Sent: 4/03/2025 3:54:14 PM
Subject: DA number 2024/1835 Objection from Emma Grose & Michael Groom - 15 Clifford Ave Fairlight

Regarding DA number 2024/1835

ADDRESS: 10-12 CLIFFORD AVENUE, 33-35 FAIRLIGHT STREET, FAIRLIGHT

PROPOSED DEMOLITION & CONSTRUCTION OF NEW RESIDENTIAL

Extract of Low & Mid-Rise Housing Policy Indicative Map

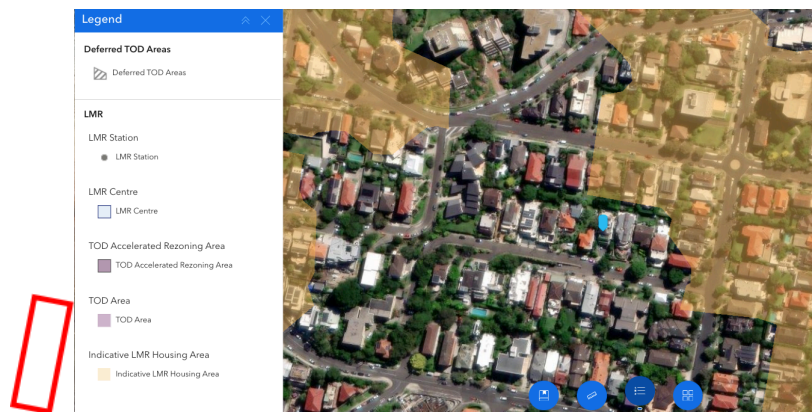
It is noted that the southernmost properties of the development site, (No. 10-12 Clifford Avenue) are specifically NOT included in the map relating to the NSW Government's Stage 2 Low & Mid Rise Housing Policy.

Therefore, this portion of the property will not benefit from any additional height or floor space controls. Further, the two properties on Fairlight Street (33 & 35) are actually outside the 800m radius from Manly Wharf.

Extract of Council Stormwater Map

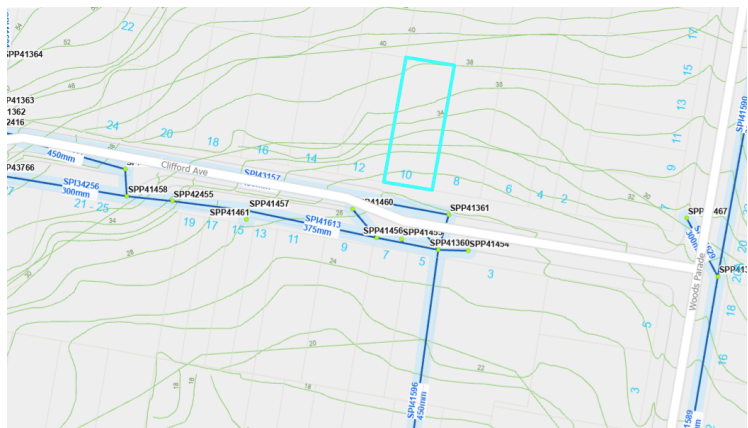
The proposal provides for all collected stormwater to ultimately be discharged to the street gutter in Clifford Avenue.

The run off from this proposed development – and the addition of 15 more households will result in drainage that simply cannot cope with the demands put upon it.

The concentration of all stormwater from the properties on the northern side of Clifford Avenue as well as the road drainage results in localized flooding, which affects No. 5, 7 and 9 Clifford Avenue. This flooding is identified on the Council's flood hazard map.

There is concern that the proposed development will further add to the flooding. It has not been demonstrated that the existing drainage infrastructure can support the proposed development and associated runoff.
